**CITY OF TEMPE
DEVELOPMENT REVIEW COMMISSION**

**Meeting Date: 08/13/2019
Agenda Item: 3**

ACTION: Request a Development Plan Review for a new five (5) story hotel containing 102 keys for VIB TEMPE, located at 511 South Farmer Avenue. The applicant is Huellmantel & Affiliates.

DPR190096 Development Plan Review including a site plan, building elevations and landscape plan.

SITE PLAN
1" = 20'-0"

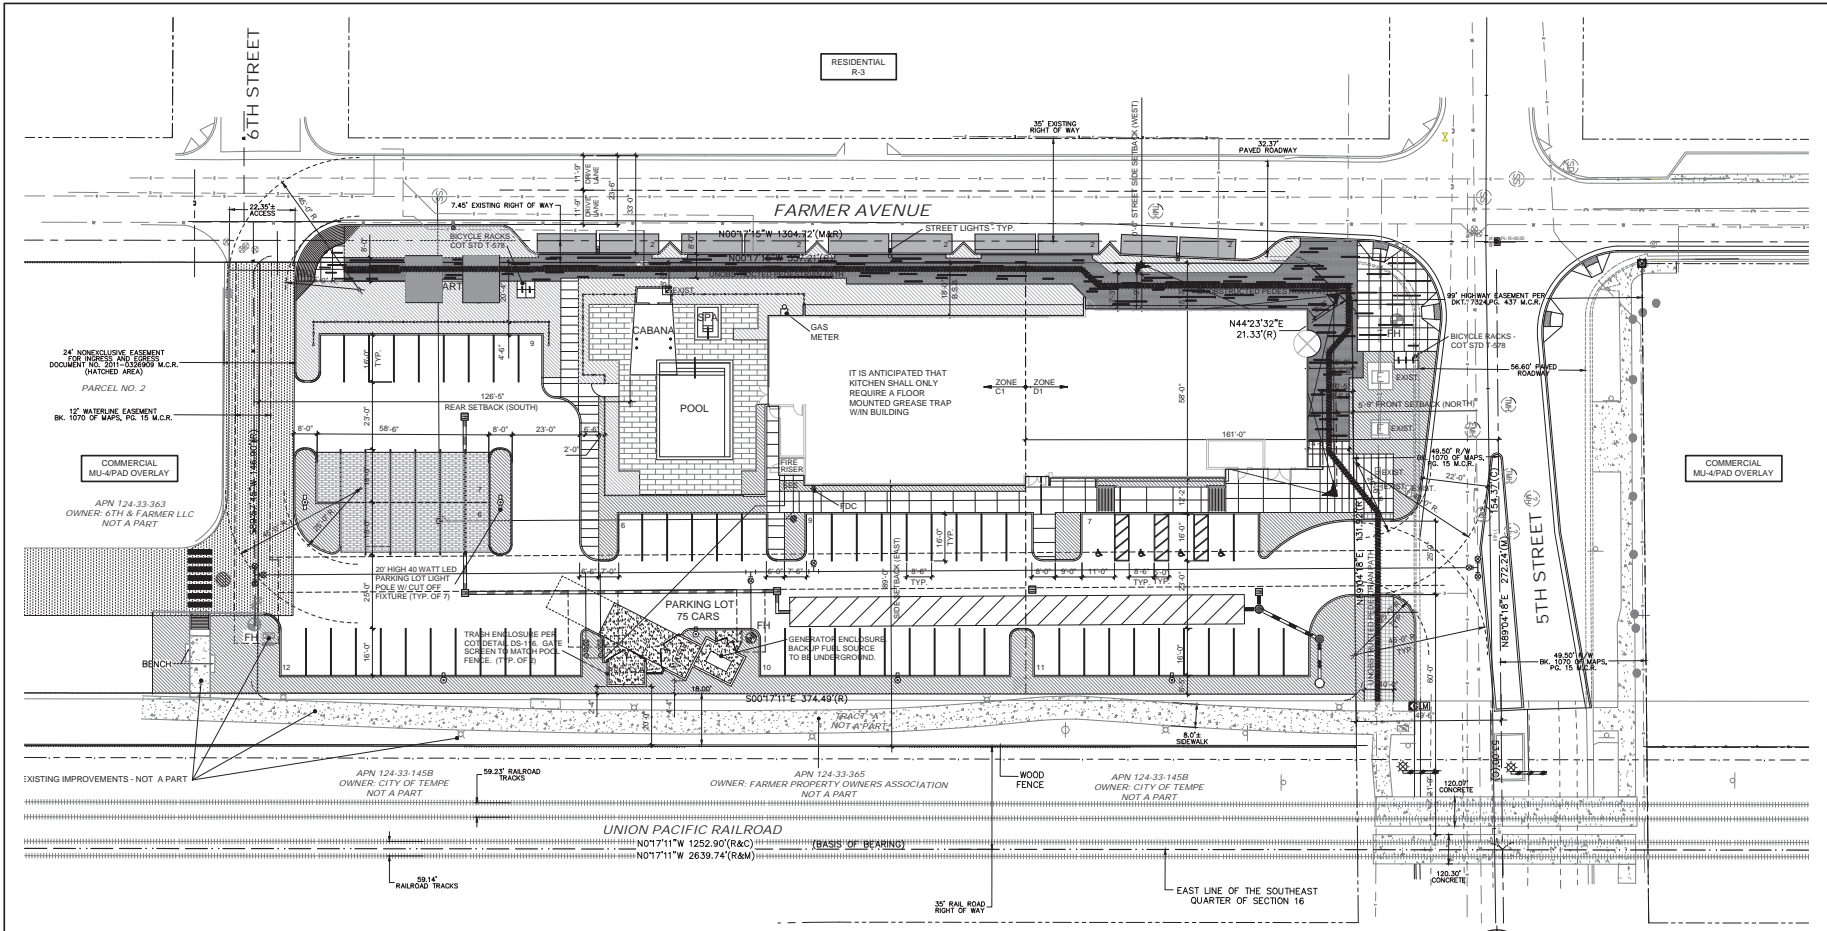
This site is approximately +/- 1.26 acres and rectangular in shape; and the lot coverage for this project is proposed at 19.13%. The applicant is proposing a surface parking lot which can be accessed from two driveways, one on each of the lot frontages; on-street parking spaces are also provided. This site will have a connection to the development directly to the south, which will allow for better circulation for the Fire and Solid Waste servicing. There will be an outdoor pool amenity area on the ground floor. Staff has added a condition of approval for the applicant to provide parking lot screen walls.

9. **Provide 3'-0" screen walls on-site along parking area from street view; these walls shall complement the materials/finishes of building and must be opaque.**

SHEET TITLE:
ILLUSTRATIVE LANDSCAPE PLAN

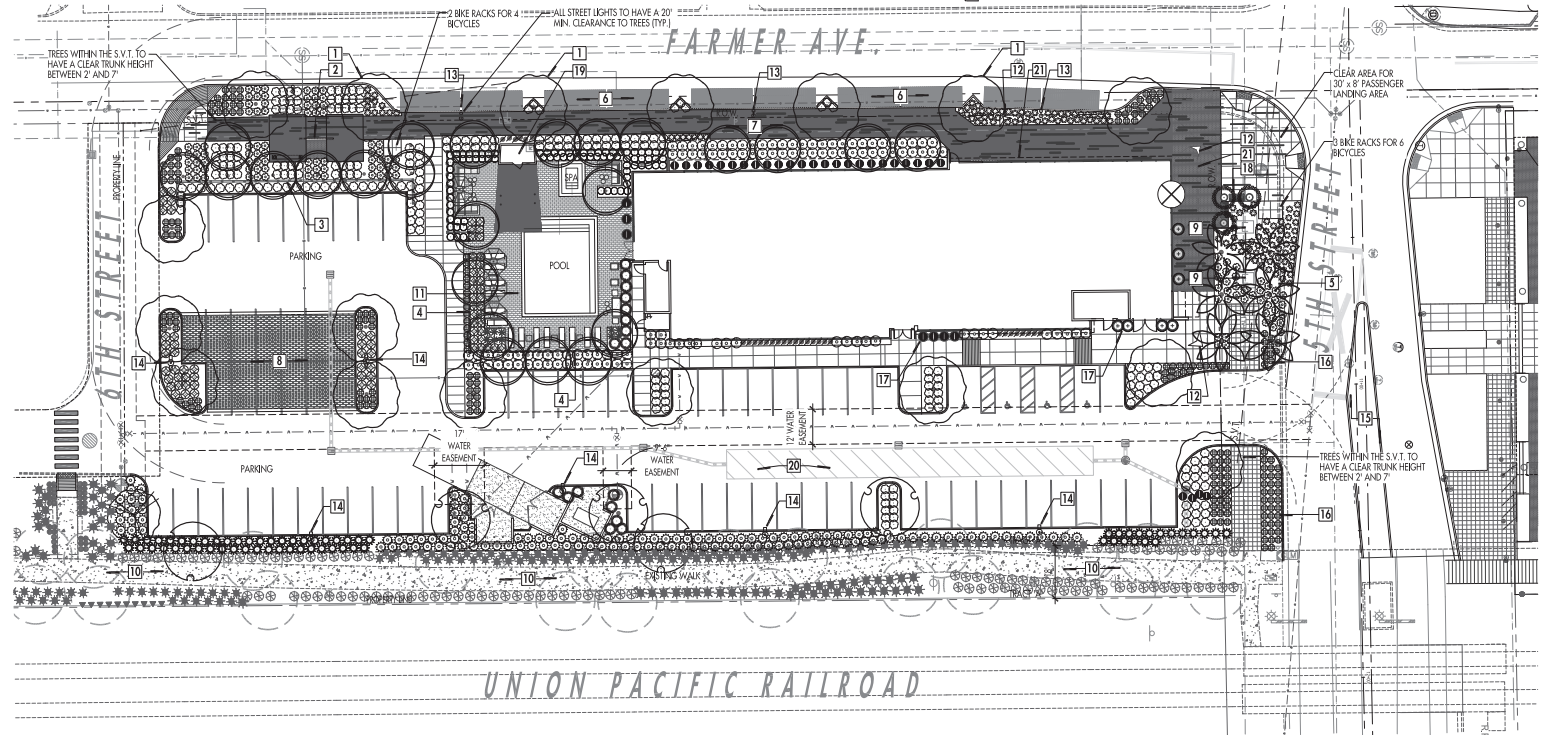
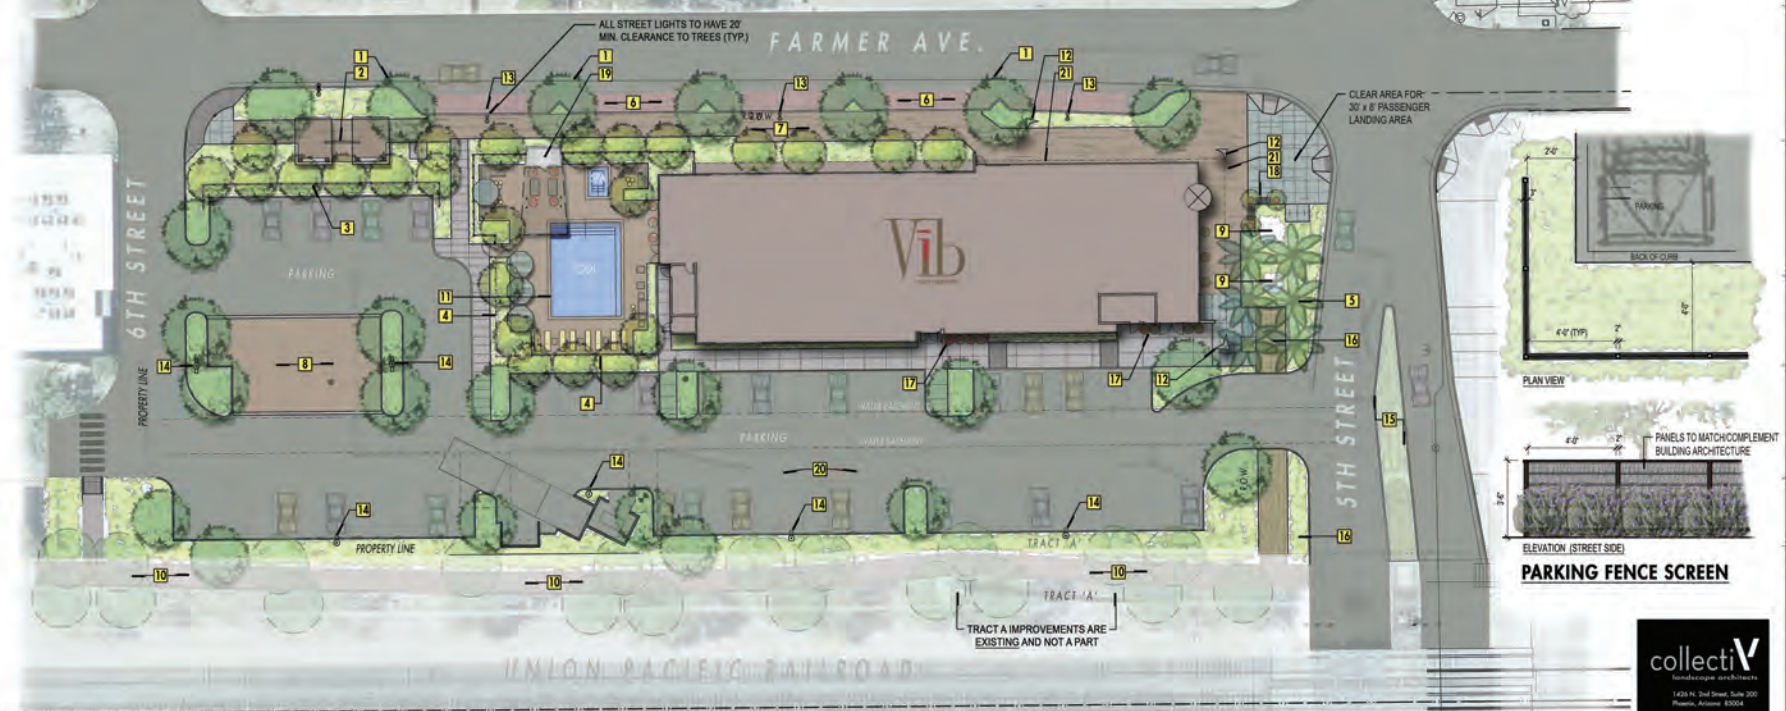
The site will be well landscaped, the proposed coverage is 25% and only 7% is required. The proposed palette will be consistent with the existing and entitled projects within the Farmer Arts District – Parcel 1 PAD. Staff has added a condition of approval requiring the applicant to work with staff on the landscape along 5th Street; to ensure the minimum number of street trees are provided (must be of a shade variety) while meeting the 5th Street Streetscape project, and having this landscape mirror the development on the north side of 5th Street to the greatest extent possible.

27. **Provide a minimum of four (4) street trees on 5th Street which must be of a shade variety, palm trees can be provided in excess. Trees and plants should mirror that of the proposed development on the north side of 5th Street to the greatest extent possible.**

SHEET TITLE:
ELEVATIONS

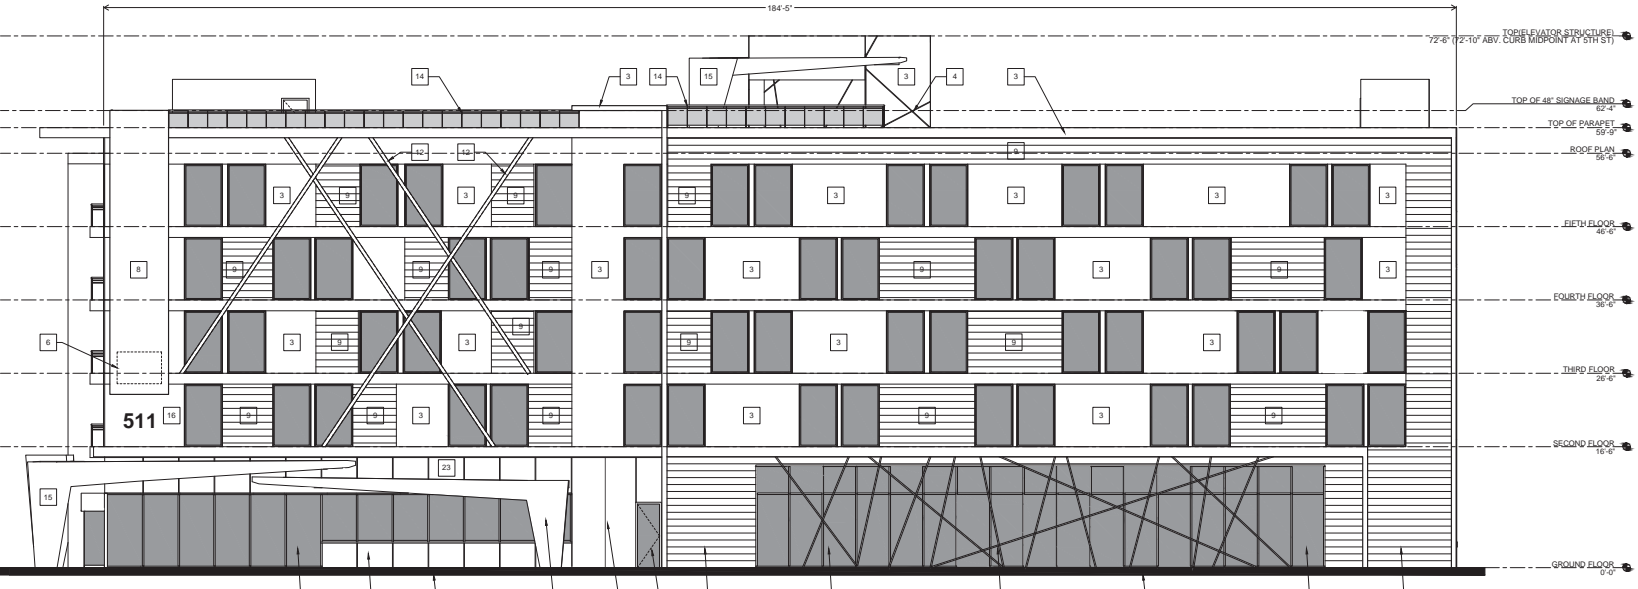
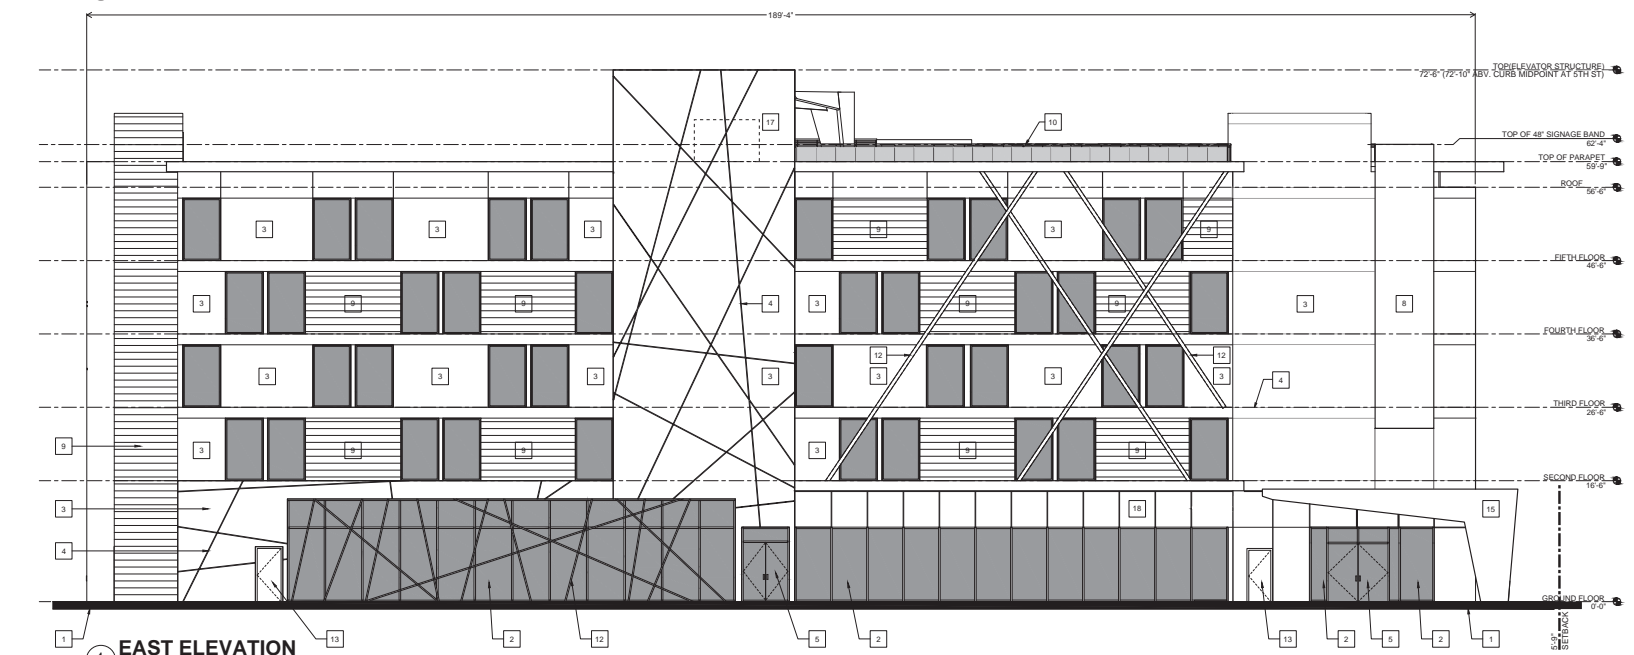
The building will be five (5) stories with a maximum height of 72'-10". There are no significant horizontal changes in the building planes, especially on the larger facades which are the east and west; but there is relief in monotony through the variation in materials, decorative score line patterning on stucco/glazing, unique columns/awnings on the northern portion of building and a distinctive accent banding which will also serve for future business sign(s).

19. **Project must maintain the proposed ground floor aluminum composite panels for building walls and complementary aluminum column wraps as show on elevations.**
20. Roof access shall be from the interior of the building. Do not expose roof access to public view.
21. Conceal roof drainage system within the interior of the building.
22. Incorporate lighting, address signs, and incidental equipment attachments (alarm klaxons, security cameras, etc.) where exposed into the design of the building elevations. Exposed conduit, piping, or related materials is not permitted.
23. Locate the electrical service entrance section (S.E.S.) inside the building or inside a secure yard that is concealed from public view.

REFUSE PLAN
 1" = 20'-0"

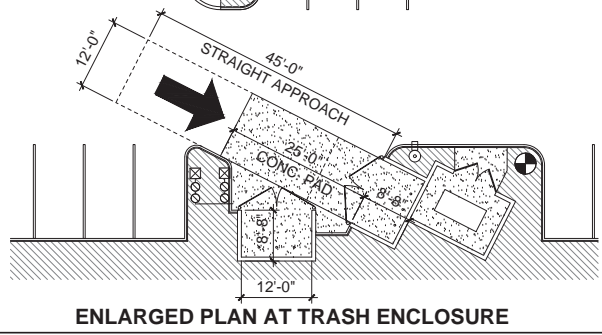
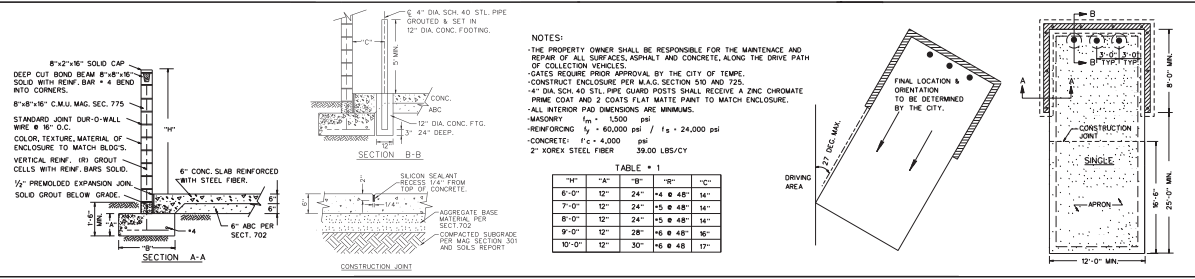
10. **Refuse and generator enclosures should be designed to complement building design; must provide additional materials/finishes from the building palette to these enclosures and/or provide the decorative crossing score line patterning that is propose on portion of the building.**

- Enclosure indicated on site plan is exclusively for refuse. Construct walls, pad and bollards in conformance with standard detail DS-116.
- Contact the Solid Waste Division to verify that vehicle maneuvering and access to the enclosure is adequate. Refuse staging and collection must be on site; no backing onto or off of streets, alleys or paths of circulation.
- Develop strategy for recycling collection and pick-up from site. Roll-outs may be allowed for recycled materials. Coordinate storage area for recycling containers with overall site and landscape layout.
- Gates for refuse enclosure(s) are not required, unless visible from the street. If gates are provided, the property manager must arrange for gates to be open from 6:00am to 4:30pm on collection days.
